## COUNCIL ASSESSMENT REPORT

| <b>DA Number</b>   | DA 58/2020/JP   |
| <b>Proposed Development</b>  | Construction of seven residential flat buildings between 8 and 9 storeys in height containing 295 dwellings. The development will comprise a two-level basement car park as well as associated communal open space and landscaping.   |
| <b>Street Address</b>  | 2A-12 Sexton Avenue and 24-34 Fishburn Crescent Castle Hill   |

**Figure 2** – Building height plane indicating exceedance to height standard

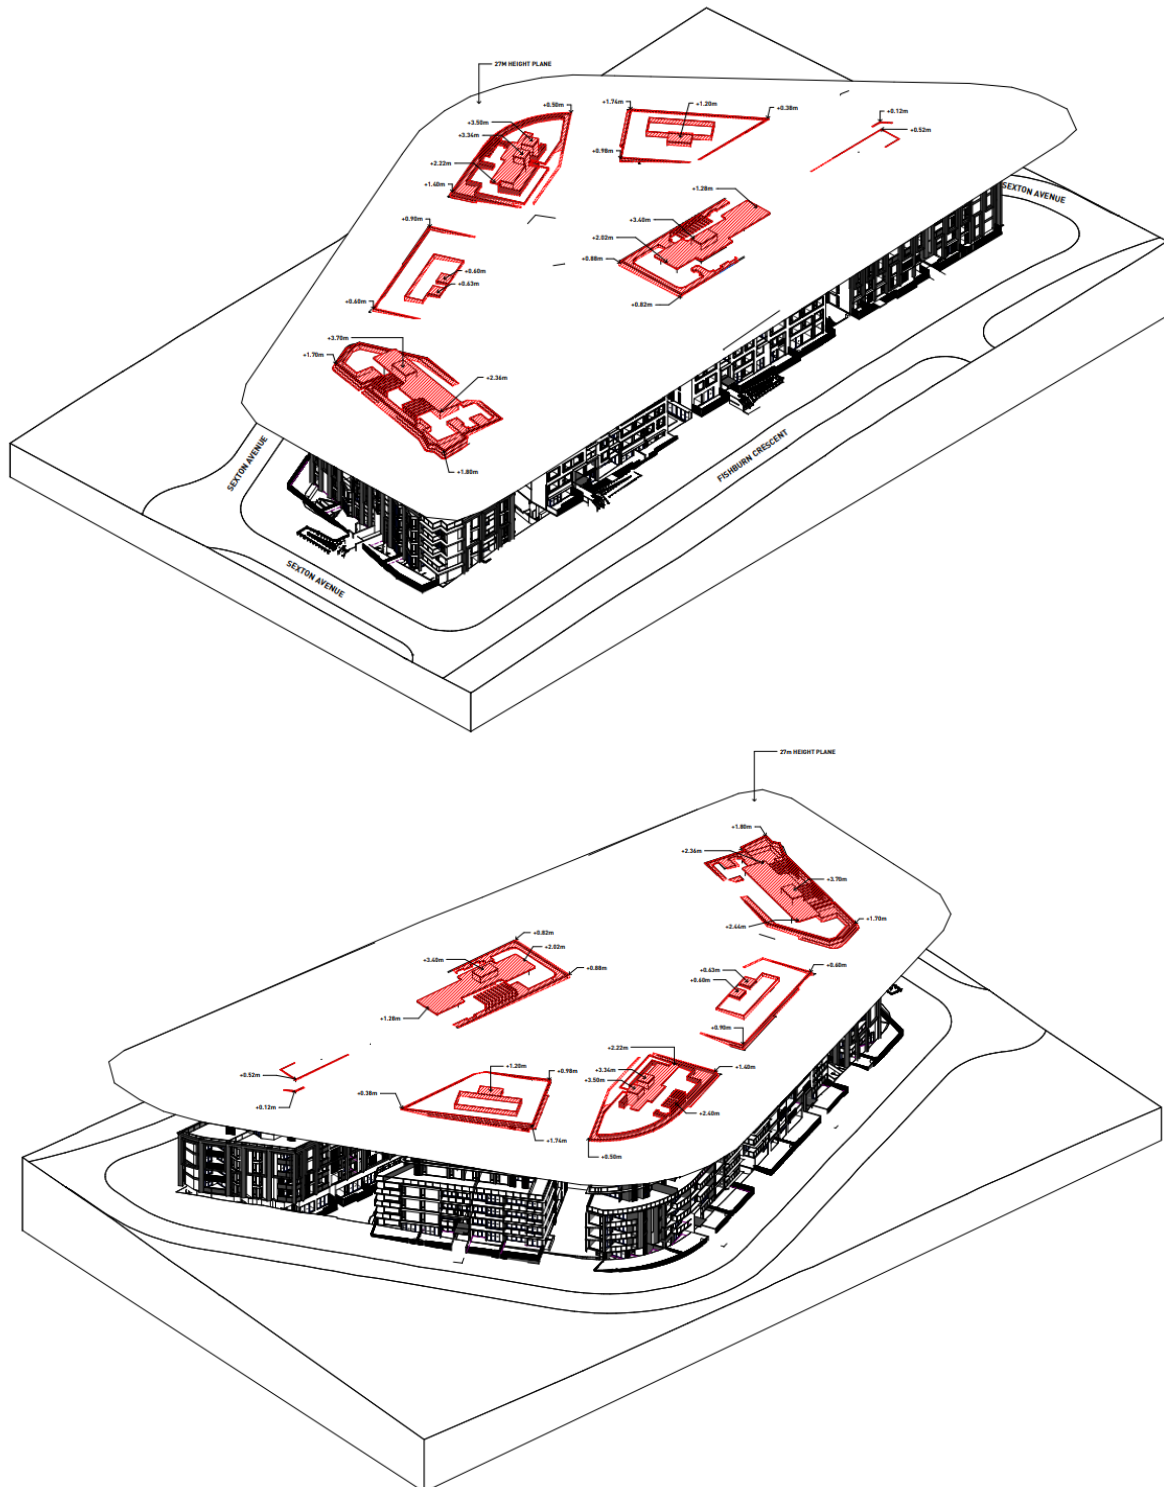
The non-compliant elements are primarily limited to the roof form for 6 of the 7 buildings (refer to Figure 2).

The proposed departure to the building height development standard will not cause adverse impacts on the amenity of adjoining properties with respect to overshadowing, privacy, view loss and perceived bulk and scale. The largest variation to the height standard occurs to Building 1 with a 3.7 metre (13.7%) variation, Building 3 with a 3.5 metre (12.9%) variation, and Building 6 with a 3.4 metre (12.5%) variation. This relates to lift overruns/plant services and communal roofs to provide for common open space. Similarly, the variations to Buildings 2, 4 and 5 also relate to lift overruns, stair roofs or service plants which are centrally located on the roof. This, together with the generous 10m and 7.5m front setbacks and 4m upper level setbacks ensure that the lift overrun and roof form would not be a source of significant shadow cast and is considered to integrate well with the form of the building when viewed from the streetscape.

**Figure 3** – Eastern elevation of Building 5 with variation outlined in red

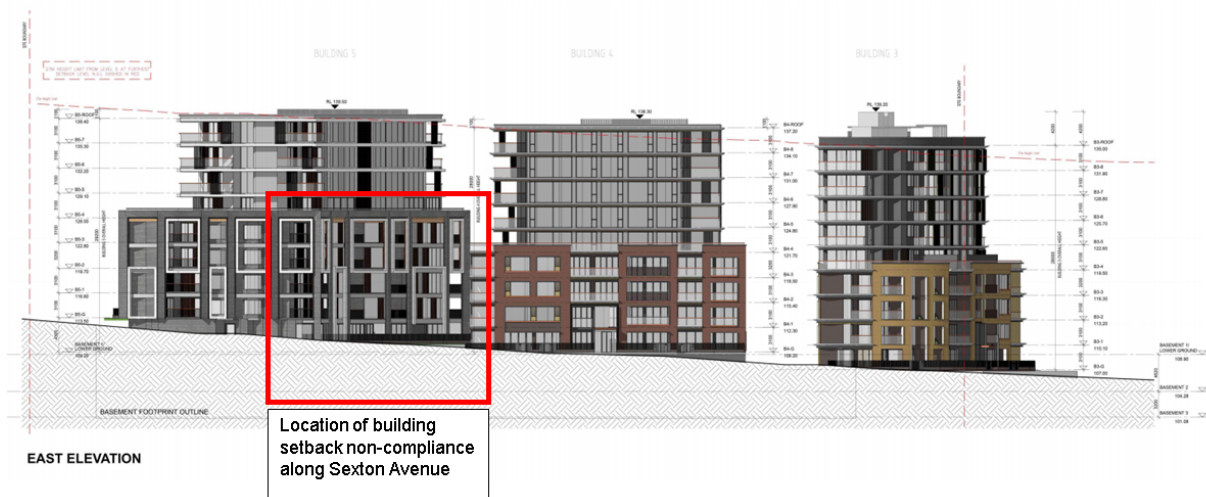
The DCP requires that for development within the Showground Precinct, that storeys above the fourth storey shall be setback a minimum of 4 metres behind the front building line. For buildings 5 and 6, the fifth storey and above is setback a minimum of 4 metres behind the front building line (refer to Figure 3 and 4 below).
